AGENDA
PLANNING AND ZONING COMMISSION MEETING
CITY OF CREVE COEUR, MISSOURI
MONDAY, OCTOBER 7, 2019
6:30 PM

APPLICATION TO PLANNING AND ZONING COMMISSION #19-030 NEW LED PARKING LOT AND BUILDING LIGHTING FOR THE NATIONAL COUNCIL OF JEWISH WOMEN AT 295 N. LINDBERGH BOULEVARD

REVISED PROPOSAL

Figure 1: New Light Standard from Ameren that are LED and downcast

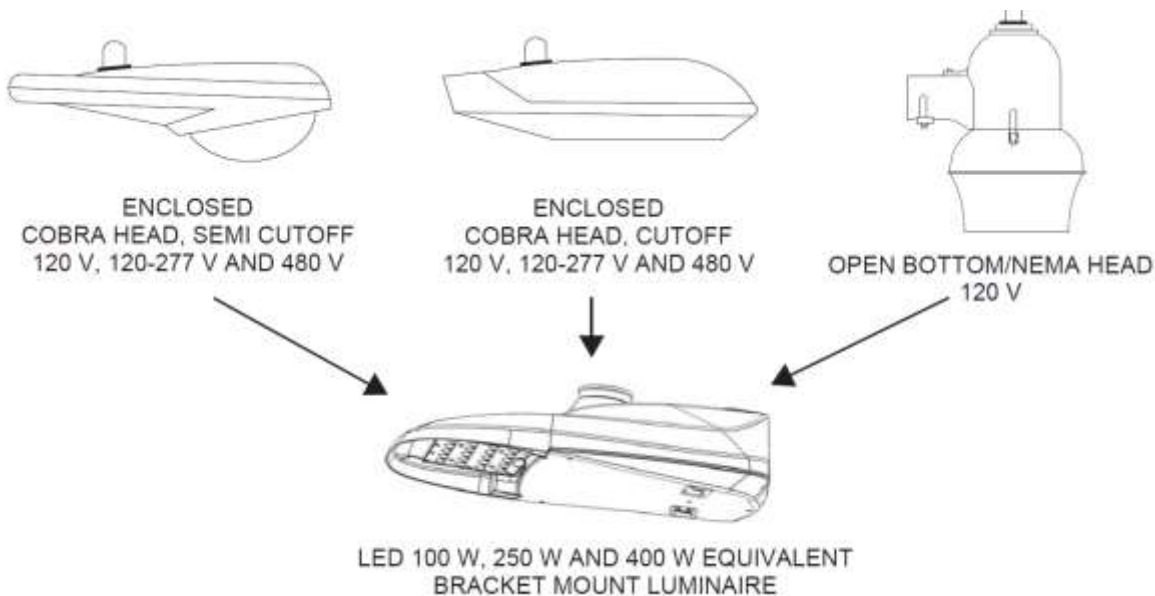
During the August 19th Planning and Zoning Commission, Staff found that the proposed new light fixtures were consistent with the regulations in that they are downcast and will not be directed onto adjacent property. However, Staff included a condition that the pre-existing non-conforming lights on the Ameren utility poles were to be removed. The NCJW had requested maintaining those lights. The Commission continued the item to allow the Applicant to determine if those lights could be replaced with new light fixtures that would comply with the City's regulations with the new lights from Ameren. The Applicant has indicated that Ameren will replace the non-conforming lights with new LED light fixtures that are downcast and shielded, and provided the Ameren information for these fixtures. A photometric plan is not available and the Applicant's lighting contractor is unable to provide a photometric plan for any lights that they don't source. Therefore Staff is unable to verify the brightness levels of the new Ameren lights.

3. The existing non-conforming Ameren lights on the utility poles shall be replaced with new LED fixtures that are downcast and shielded to comply with Section 405.680 Lighting, with a maximum height of 24 feet as measured from the bottom of the base at grade to the top of the fixture, as shown on the submitted information received October 1, 2019.

Figure 2: Close-up of the Site Photometric Plan, showing the location of the two pole mounted light fixtures.

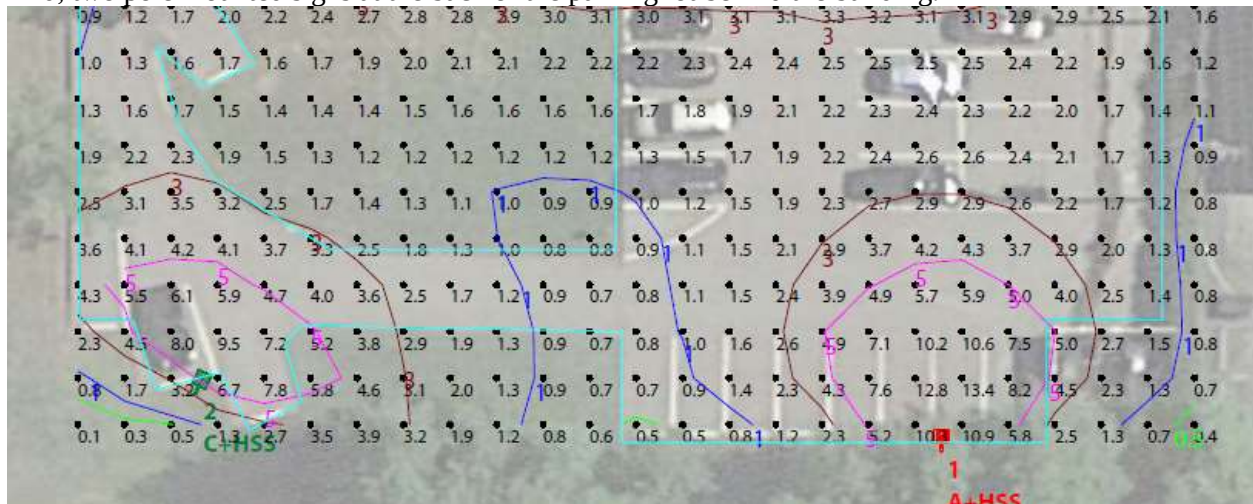
The pole mounted fixtures are also a bronze color, and both have a wattage of 150w, and have a back shield to direct the light away from the residents. The height of the pole is 20 feet.

The light fixtures comply with these regulations. The parking lot is approximately 38 feet from the west property line, closest to the residents, with mature landscaping. The photometric plan is showing that living levels just below the fixture is 10.9 for the one identified in red, and where lighting levels significantly drops down as you move out. The fixtures will have shields to prevent the lighting from leaving the parking lot area or casting upon the adjacent property.

Figure 6: Close-up of the Photometric Plan of the light levels along the south property line from the building,

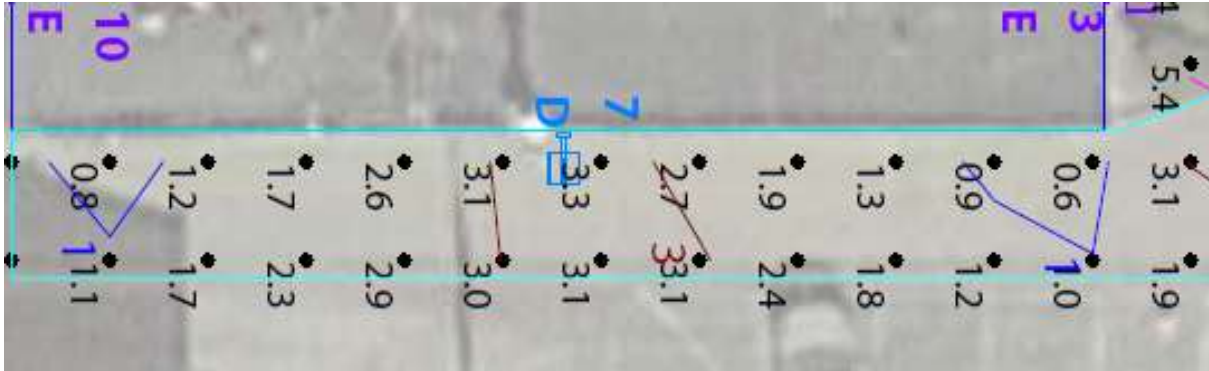
The building lighting is replacing the pre-existing, non-conforming lights, with new LED light fixtures that are downcast and in compliance with the requirements. The photometrics does indicate that along the south side of the building adjacent to the commercial property that light levels are at 3.1. However, this is adjacent to the parking lot that is in front of the office building, and therefore Staff does not have a concern with the lighting levels in this area.
